Application No. 10/661,833
Paper Dated April 15, 2005
In Reply to USPTO Correspondence of December 15, 2004
Attorney Docket No. 0388-031780

REMARKS

AMENDMENTS TO THE DRAWINGS

FIG.2

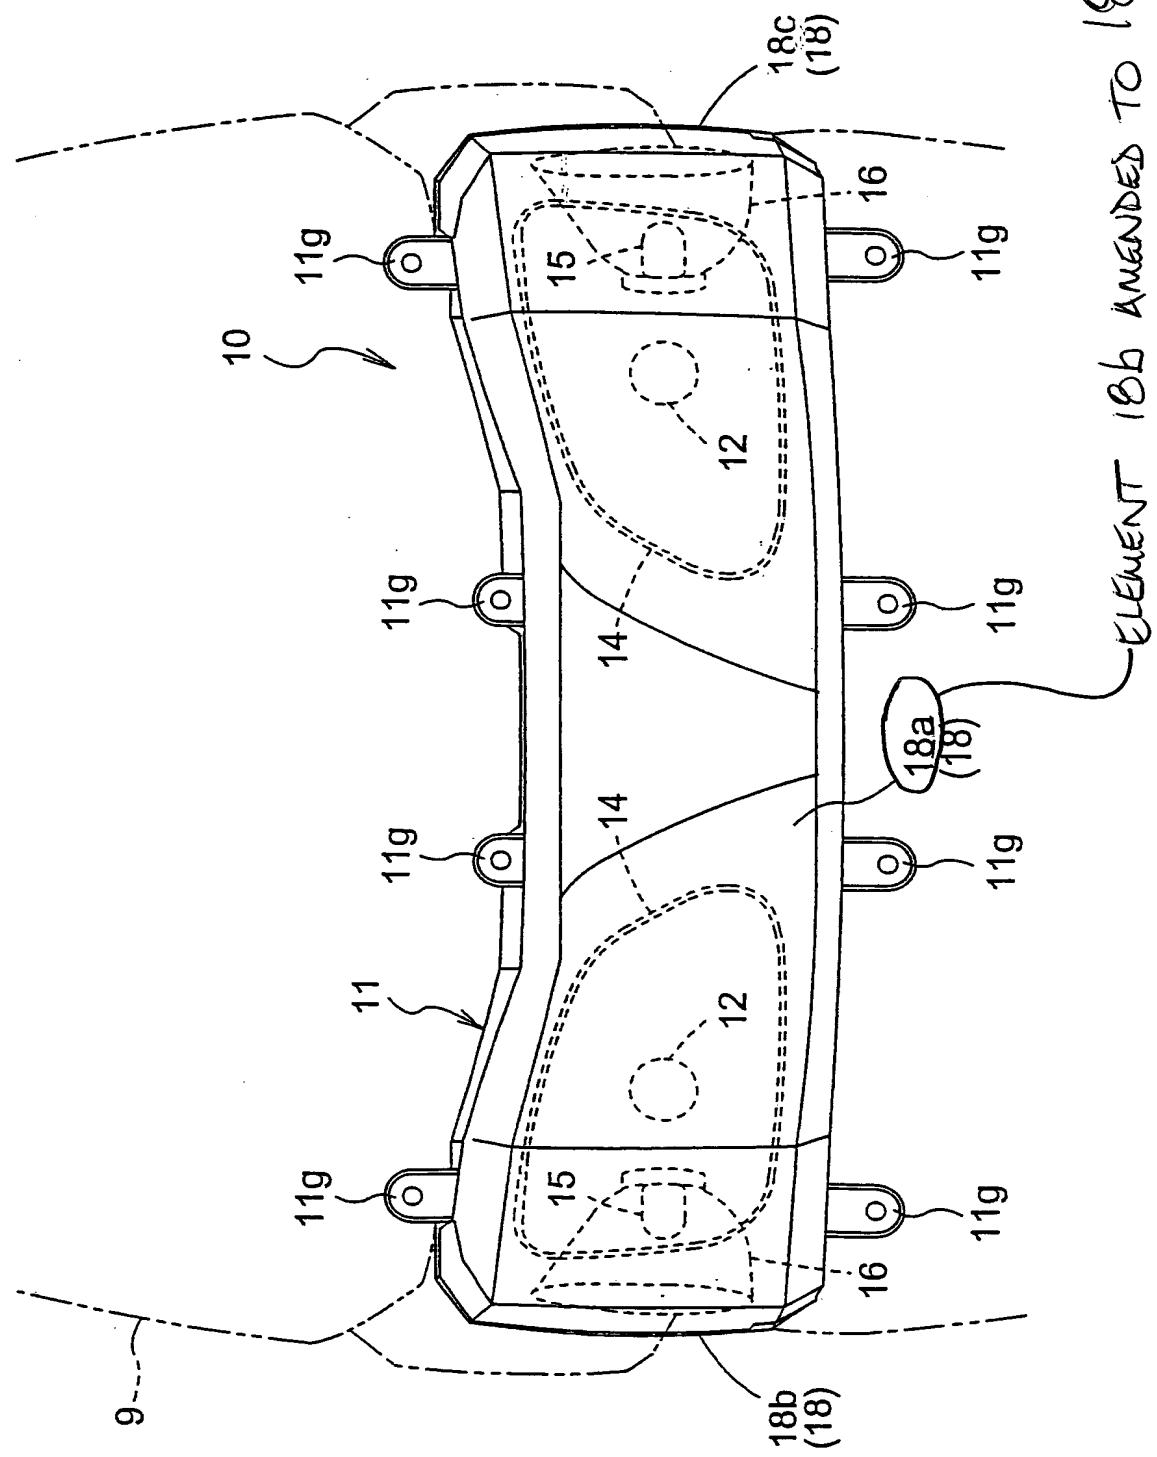
The attached sheets of drawings include changes to Fig. 2, Fig. 3 and Fig. 4. The attached sheets, which include Figs. 2-4, replace the original sheets including Figs. 2-4. In Fig. 2, an element 18b has been amended to element 18a. In Fig. 2, Fig. 3 and Fig. 4, an element 18b has been amended to element 18c.

FIG.3

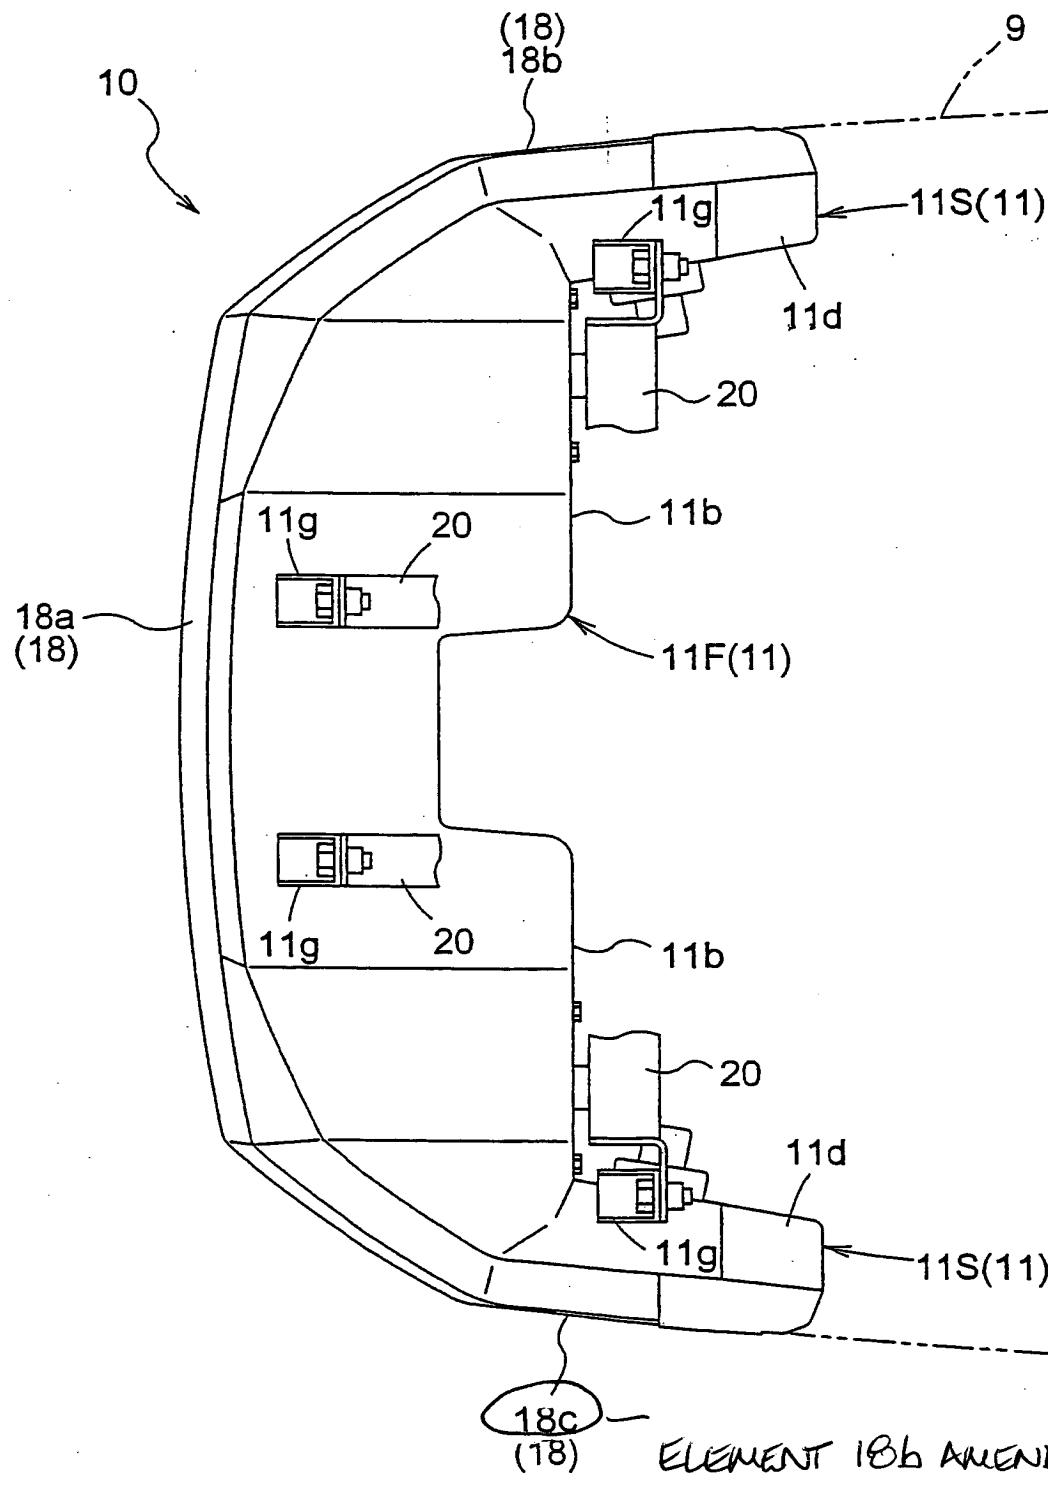
ELEMENT 18b AMENDED TO
18c
